COMMITTEE OF THE WHOLE – SEPTEMBER 19, 2005

YONGE STREET CORRIDOR PUBLIC TRANSIT IMPROVEMENTS INDIVIDUAL ENVIRONMENTAL ASSESSMENT – REGION OF YORK COMMENTS TO THE MINISTRY OF THE ENVIRONMENT EA FILE NO. MU-1033

ULTIMATE INTERFACE DESIGN AT STEELES AVENUE

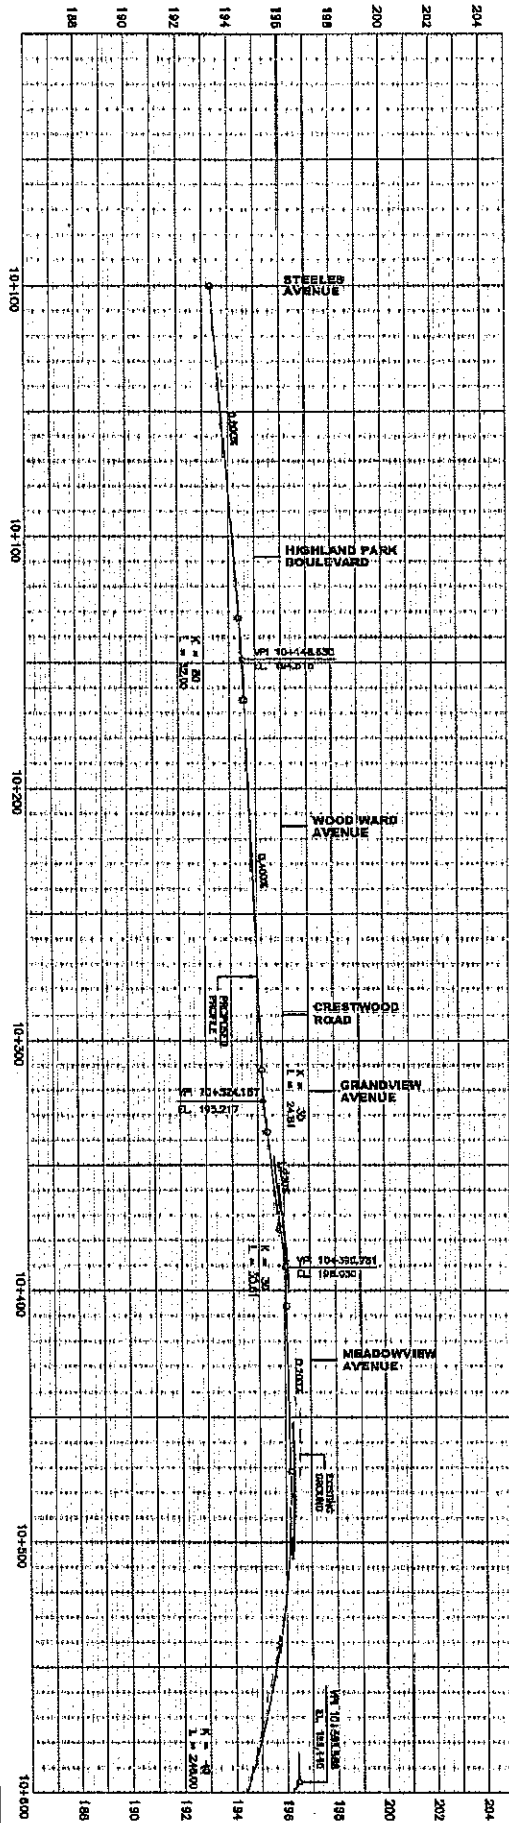
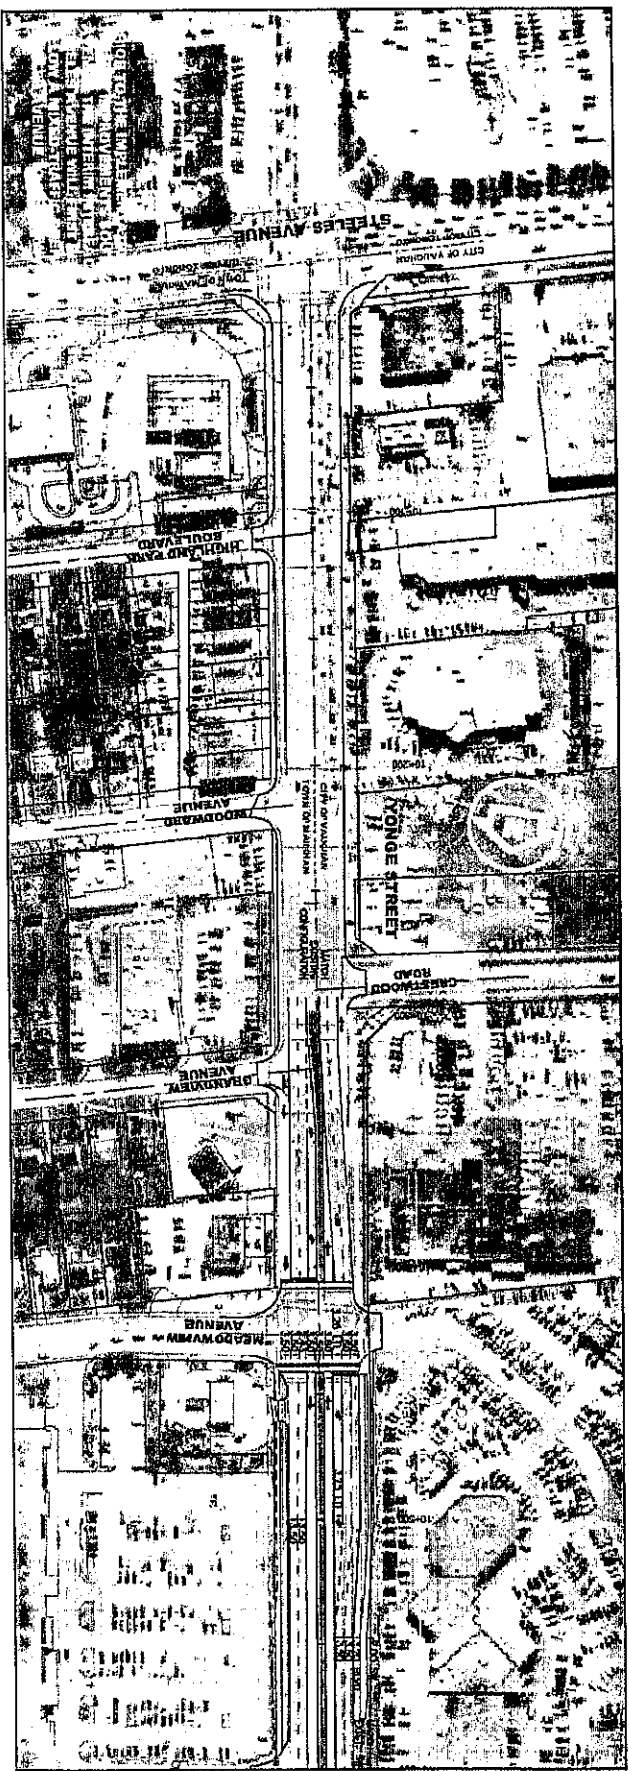
Attachments 2a and 2b show two design alternatives for the transitway at Steeles Avenue. The Attachment 2a version shows a design assuming a connection to a TTC median transitway south of Steeles Avenue, connecting to Finch Station. The TTC is undertaking a Class EA to develop this connection and it is currently nearing completion. For the most part, this section of Yonge Street employs the cross-section shown in Attachment 3a, with the median landscape strip. A station is provided at Meadowview Avenue (Markham), which is opposite the entrance to the Auto Mall in Vaughan.

INTERIM INTERFACE DESIGN AT STEELES AVENUE

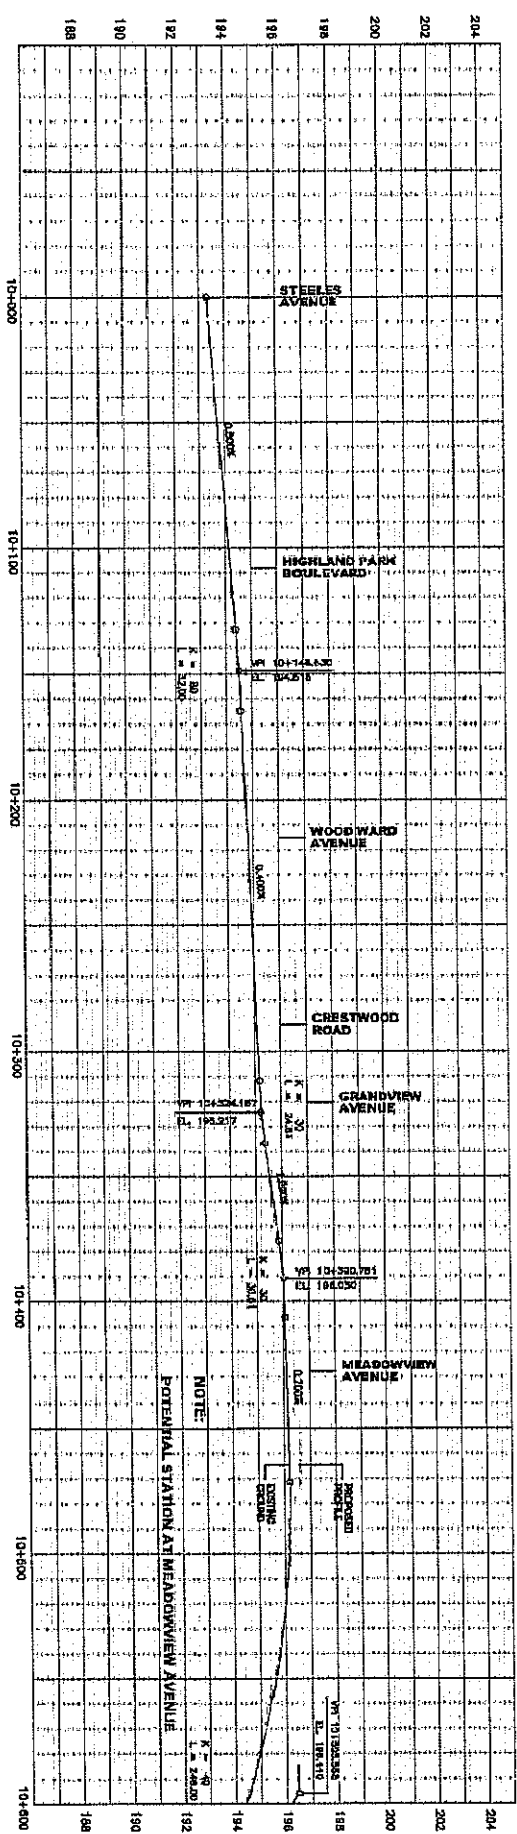
Attachment 2b shows the interim solution, should the TTC transitway not proceed concurrently with the York Region Plan. Under this scenario the median transitway starts immediately to the north of Crestwood Road.

Yonge Street Corridor Public Transit Improvements EA.
Yonge Street bridge over CN Rail to north of
Clark Avenue

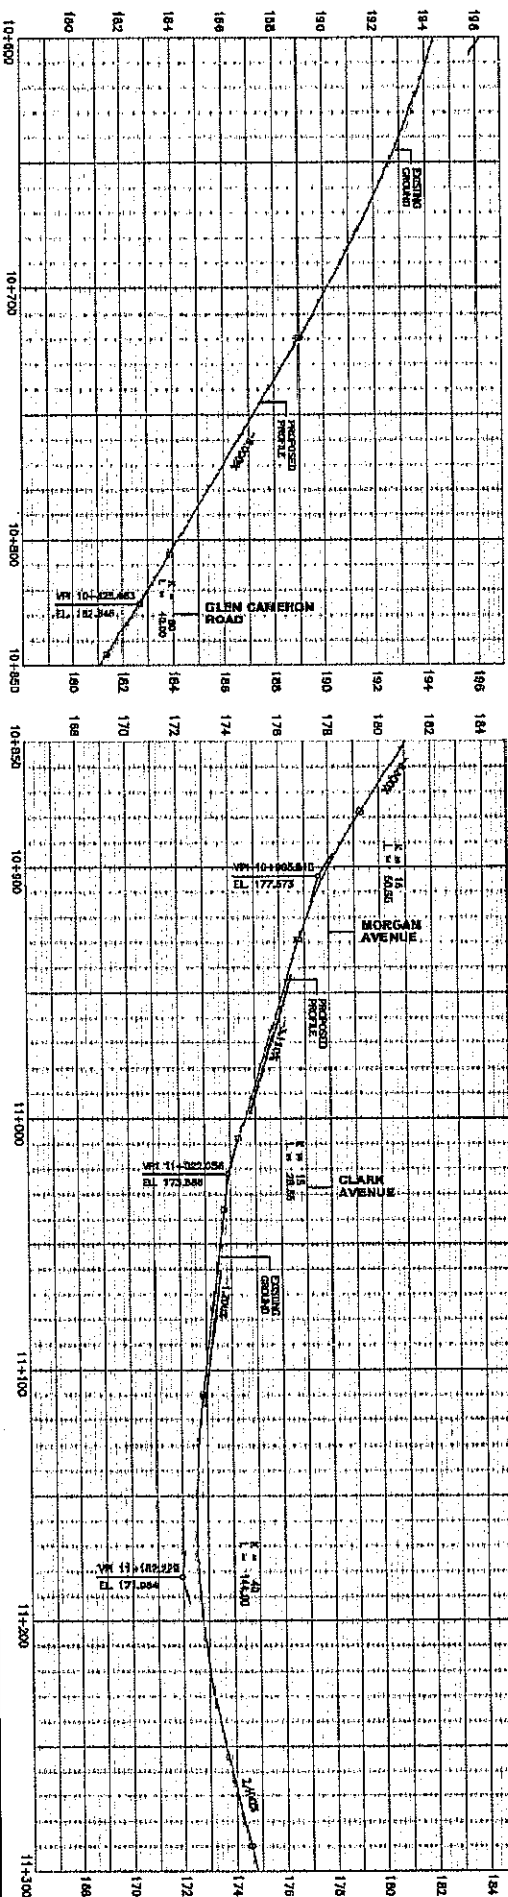
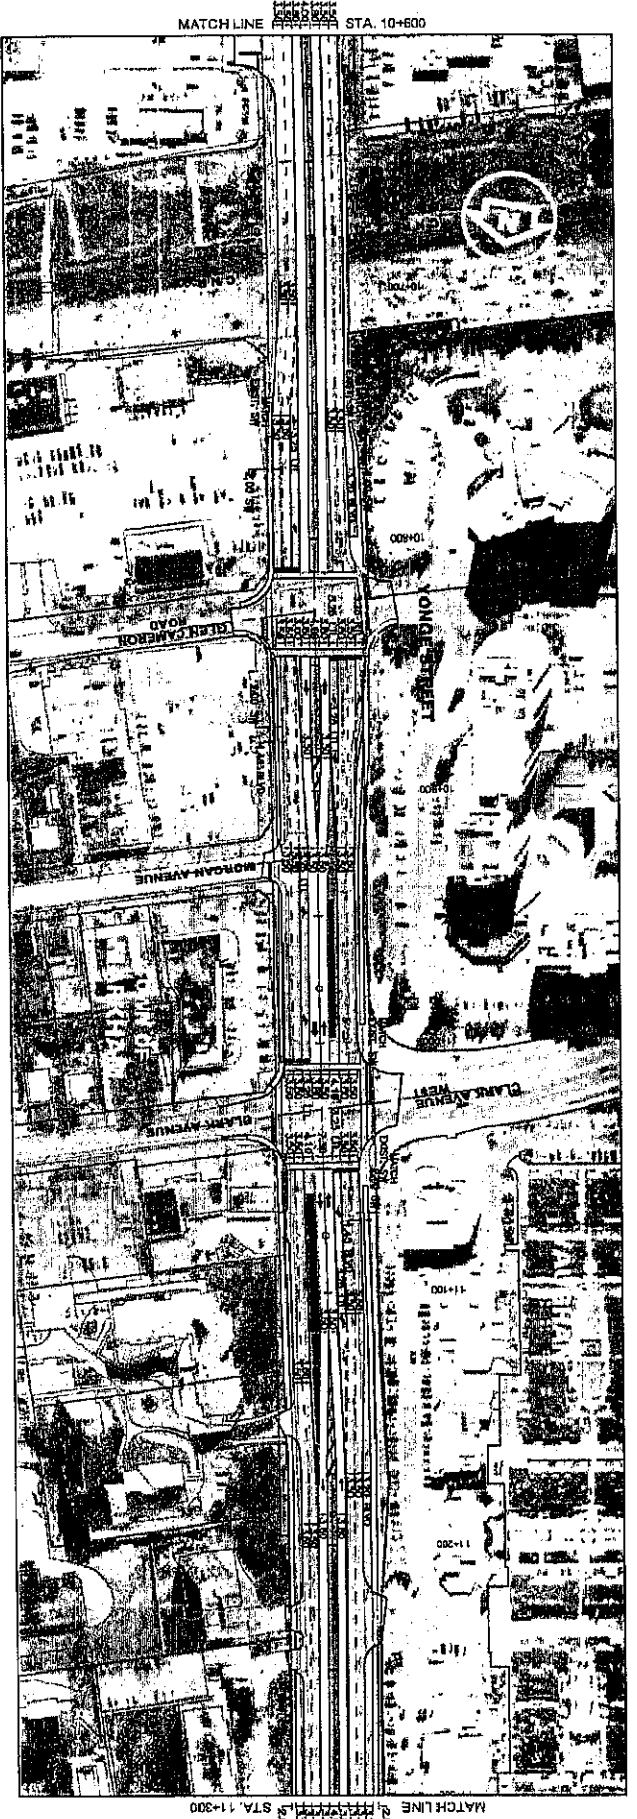
Attachment 2c details the section through the Yonge Street bridge over the CN Rail line to just past the Clark Avenue Station. The standard transitway design as shown in Attachments 3a and 3b prevails throughout most of this portion of Yonge Street.

10-3
FIGURE

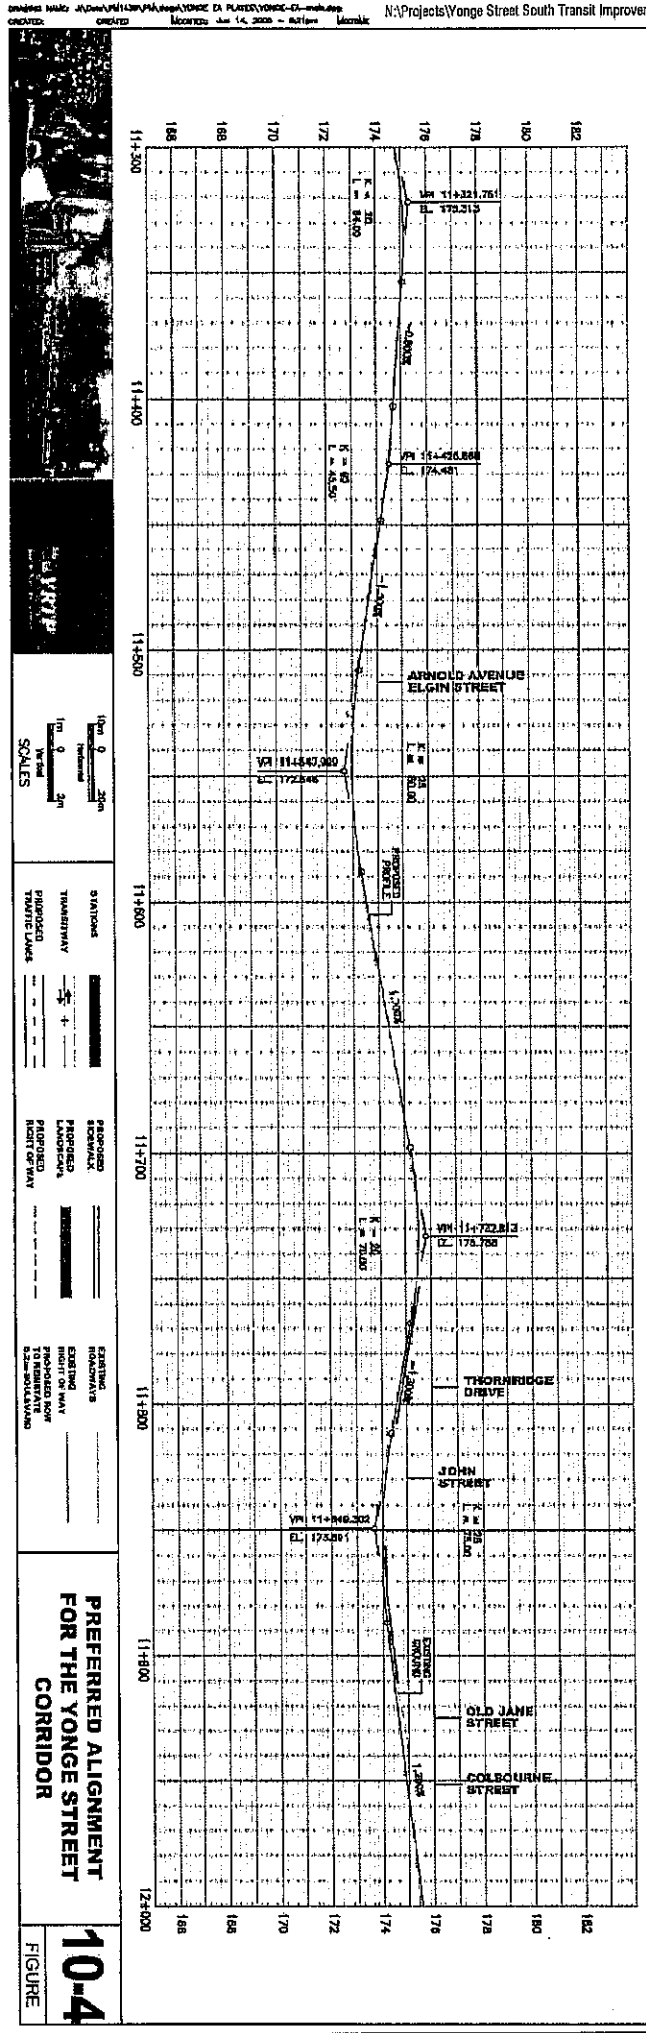
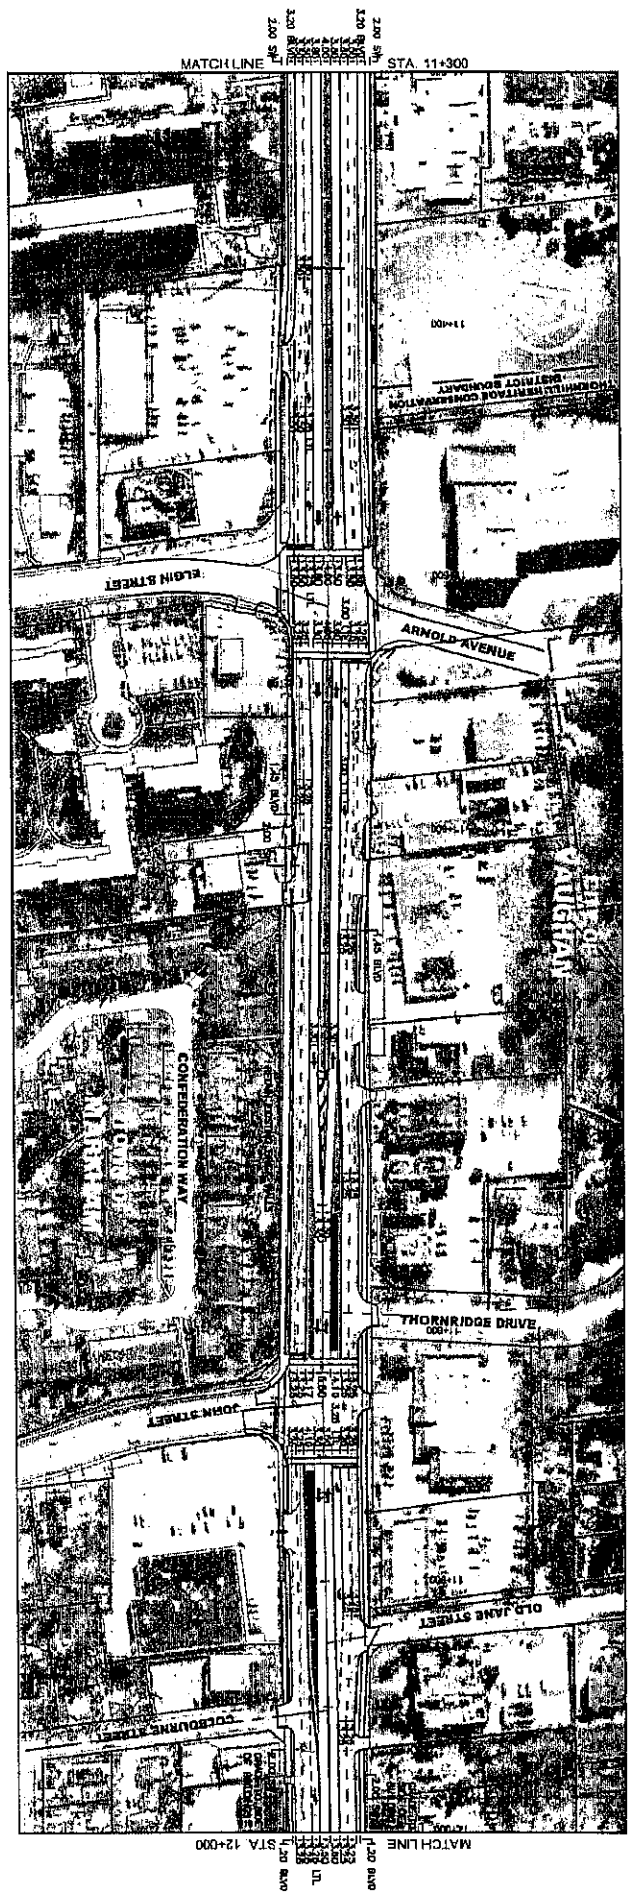
Attachment 2d illustrates the portion of Yonge Street that leads into old Thornhill and the Heritage District. From the Clark Station to the Arnold Avenue/Elgin Street intersection the standard transitway configuration is used. North of Arnold Avenue the road allowance begins to narrow. The landscaped centre median is discontinued approaching Thornridge Drive and the John Street station. The station platforms are located north (northbound) and south (southbound) of John Street. This is one of most constricted areas in the corridor and it will be a special design challenge.

Through the Arnold Avenue to Centre Street section, travel lane widths are reduced from 3.5 m to 3.25 m; the transit lanes are reduced from 3.5 m to 3.3 m; the boulevards are reduced from the standard 5.2 m to 3.2 m and the median landscaped strip is reduced from 4.0 m to 1.0 m. The 3.2 m boulevard section is composed of a 2.0 m sidewalk and a 1.2 m landscaping strip located adjacent to the travelled portion of the road. The plans still provide for street trees within this area. At the narrowest point between the buildings the resulting boulevards are reduced to 3.0 m.

The plan does not show the need for substantial land acquisitions on the Vaughan side of Yonge Street. However, if there were a decision to go to a 5.2 m boulevard throughout then additional land will have to be acquired. It is the intent of the plan to achieve the 5.2 m boulevards wherever practical, at the time of implementation, where cost effective acquisition is possible or through the site plan approval process at the time of development or redevelopment.

Yonge Street Corridor Public Transit Improvements EA. Centre Street to south of Royal Orchard Boulevard

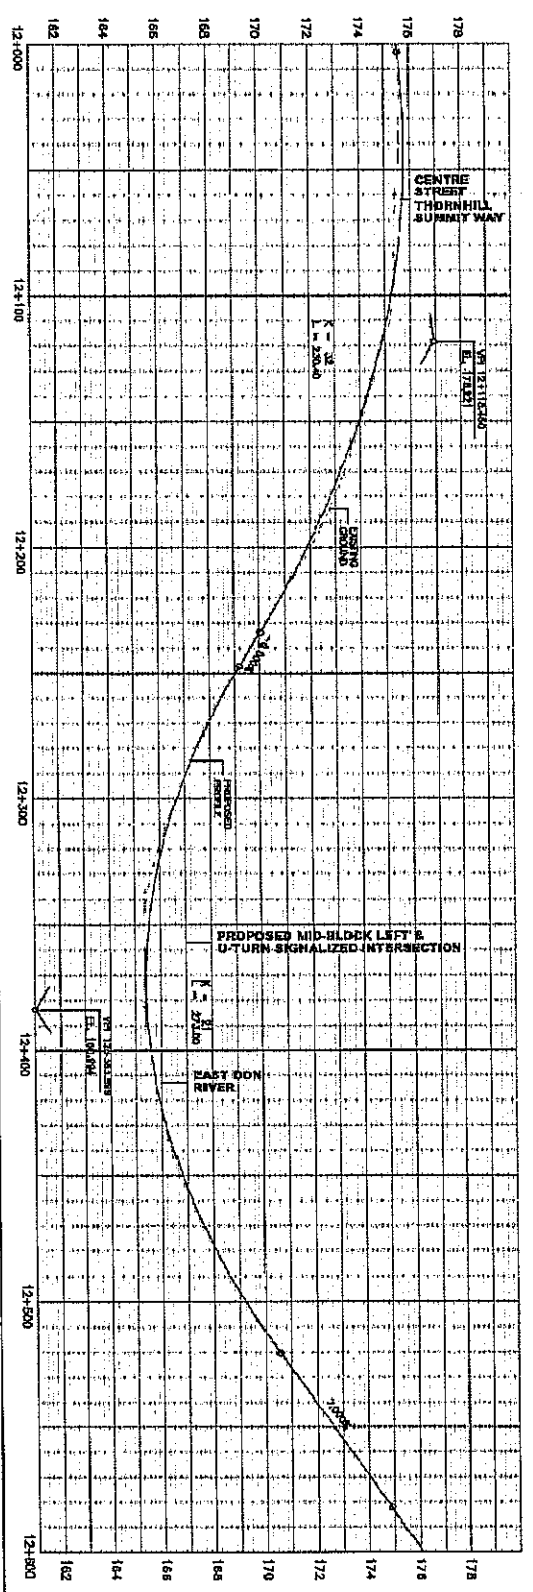
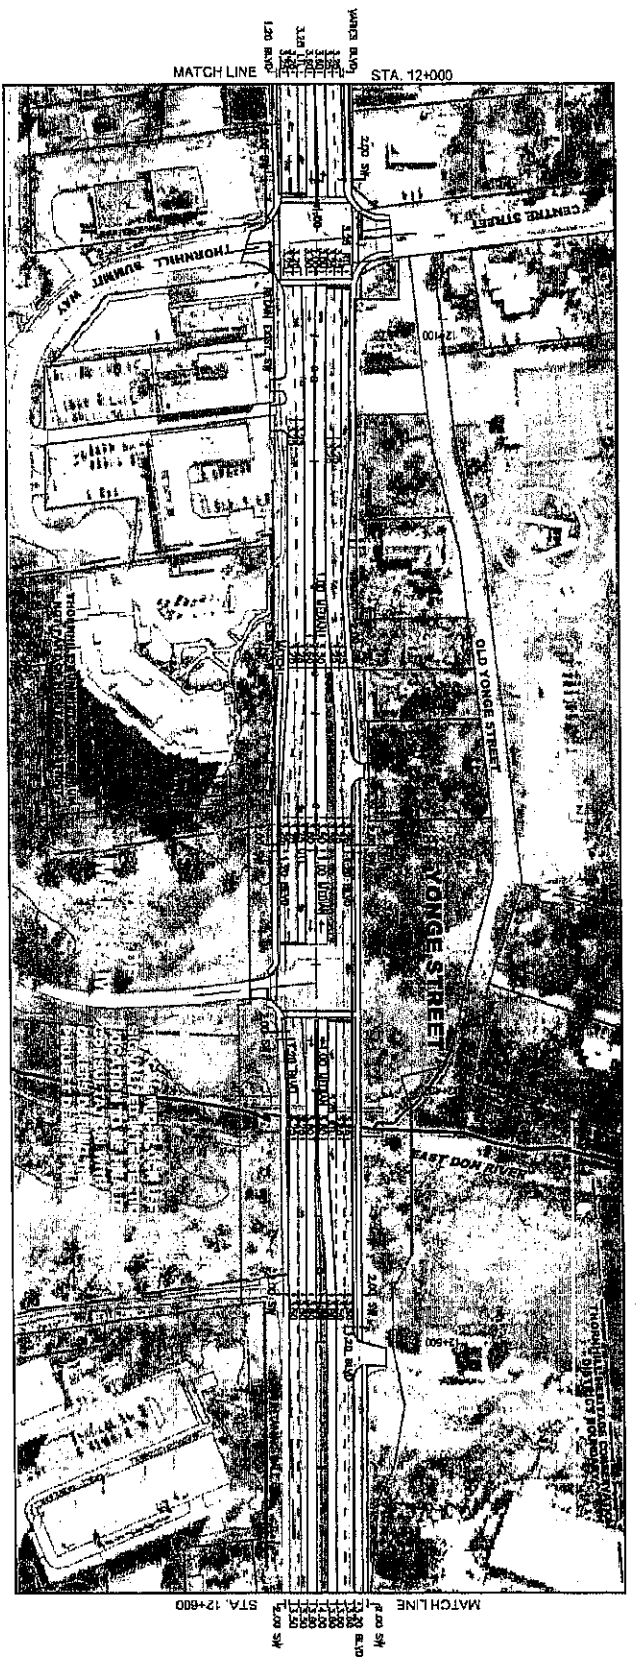
North of Centre Street, Attachment 2e shows the transitway continuing without the landscaped centre median and with narrowed boulevards until the entrance to the Toronto Ladies Golf Club. At this point, the landscaped median is reintroduced, the travel lane widths return to 3.5 m and the boulevards revert to 5.2 metres. This condition continues into the Royal Orchard Station.

It is noted that there are some inconsistencies between the initial results of the Thornhill Yonge Street Study and the recommendations of the Yonge Street EA Study. For example, the EA Study shows, north of Centre Street, the elimination of sections of the proposed 4 metre landscaped median. Also, travel lane widths south of the Arnold Avenue/Elgin Street intersection are shown as 3.5 metres rather than the proposed 3.25 metre lane widths within the historic area. It is recommended that the Region continue to work with the municipalities to reconcile any discrepancies in order to maintain and optimize the heritage/streetscape character of the affected area. This review should be conducted during the detailed design of the project.
